CITY OF FORT LAUDERDALE

# DEVELOPMENT REVIEW COMMITTEE

CASE NO. UDP-S23072

<b>CASE:</b>	UDP-S23072
<b>MEETING DATE:</b>	September 10, 2024
<b>REQUEST:</b>	Site Plan Level II Review: 4,370 Square-Feet of Warehouse Use within 100 Feet of Residential Property
<b>APPLICANT:</b>	Wayne and Kathy Schofield; Nichole Pachella, ETAL
<b>AGENT:</b>	Eduardo Marroquin Roussel Architects
<b>PROJECT NAME:</b>	1628 SW 3rd Avenue Warehouse
<b>PROPERTY ADDRESS:</b>	1628 SW 3rd Avenue
<b>ZONING DISTRICT:</b>	Heavy Commercial/Light Industrial (B-3)
<b>LAND USE:</b>	South Regional Activity Center (S-RAC)
<b>COMMISSION DISTRICT:</b>	4 - Warren Sturman
<b>NEIGHBORHOOD ASSOCIATION:</b>	Croissant Park Civic Association
<b>CASE PLANNER:</b>	Michael Ferrera

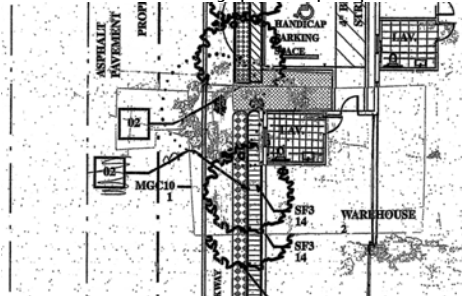
8. Dumpster enclosures shall be landscaped as per ULDR 47-19.4. Continuous planting means hedges and shrubs approximately 2 feet tall planted 2 feet apart. This may require existing paving, asphalt and/or

concrete to be removed and replaced with planting soil to a minimum depth of 3 feet and the width of the planting area is 3 feet. Please clearly note and illustrate this on plans.

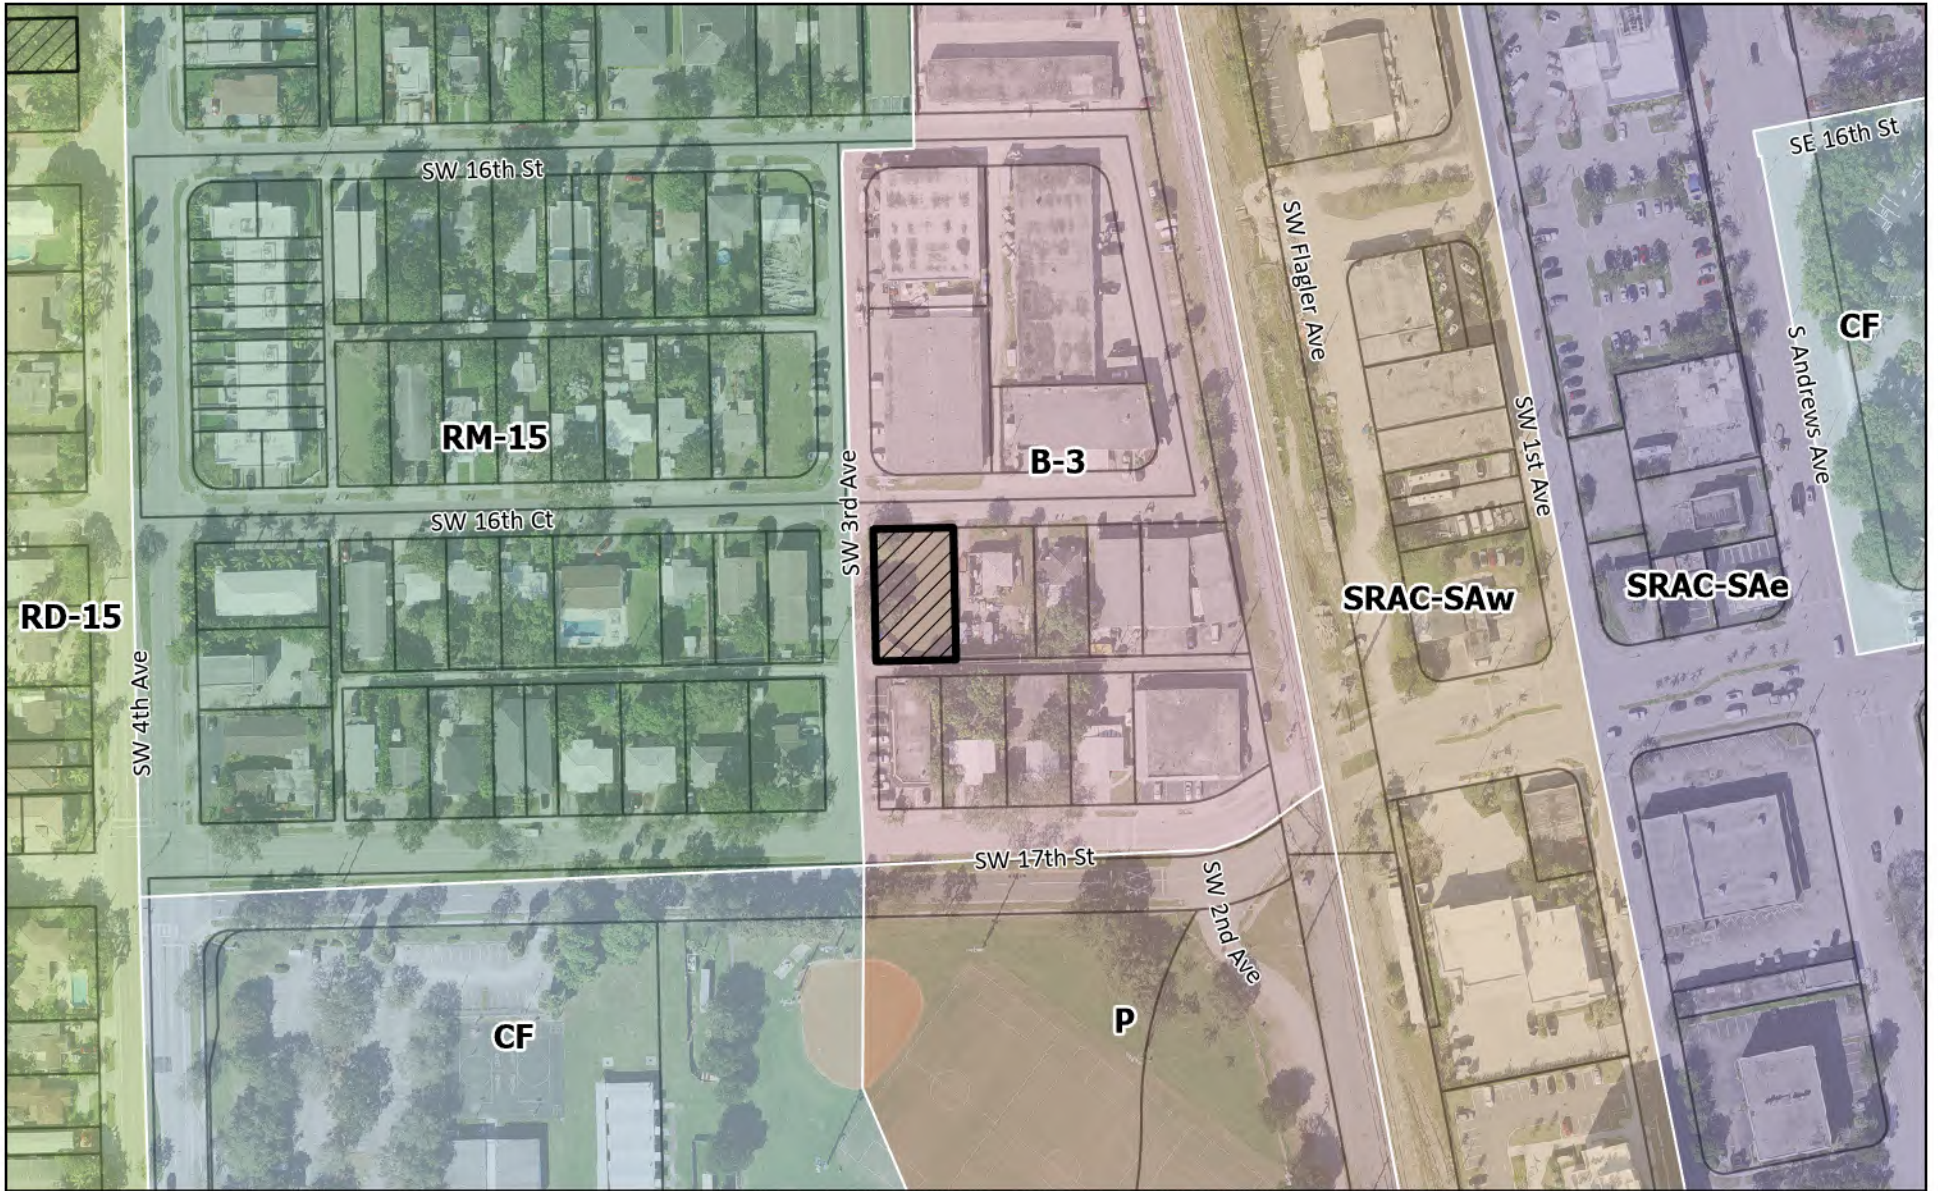
14. The proposed building materials are not clear, but the facades appear to severely lack a variation in building materials. Additional building materials should be placed throughout the entirety of the building since it is a corner lot and subject to neighborhood compatibility, with emphasis on the north and west façade facing residential. See below for sample images. These images are not all encompassing and are meant to provide a visual representation of material usage and overall design.
